Product Change Notice (PCN)

PCN Number: PCN-0454915-01

Product(s) Affected: *PJ-096H*

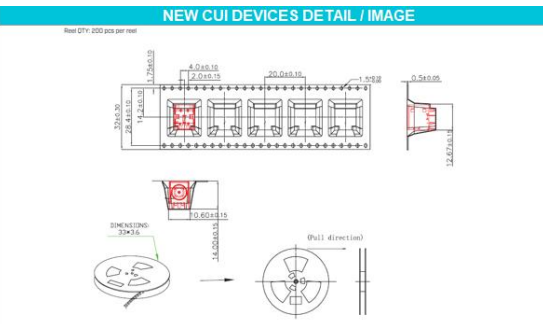
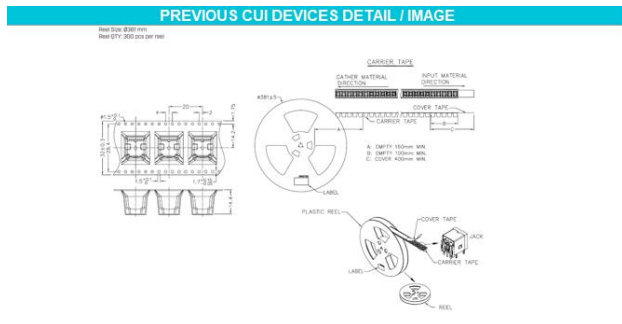
Description of Change: *Minor Housing and footprint differences. Material Change on the housing and terminals. See image Below*

PREVIOUS CUI DEVICES DETAIL / IMAGE			NEW CUI DEVICES DETAIL / IMAGE		
	MATERIAL	PLATING	DESCRIPTION	MATERIAL	PLATING/COLOR
terminal 1	copper alloy	gold flashed	terminal 1	copper alloy t=0.30	gold flash over nickel
terminal 2	copper alloy	gold flashed	terminal 2	copper alloy t=0.30	gold flash over nickel
terminal 3	copper alloy	gold flashed	terminal 3	copper alloy t=0.30	gold flash over nickel
terminal 4	copper alloy	gold flashed	terminal 4	copper alloy t=0.30	gold flash over nickel
spring	stainless steel		shield	brass t=0.35	nickel
shield	brass	nickel	insulator	LCP (UL94V-0)	black
insulator	PA10T

MATING PLUG
Jack Insertion Depth: 9 mm

MATING PLUG
Jack Insertion Depth: 9.1 mm
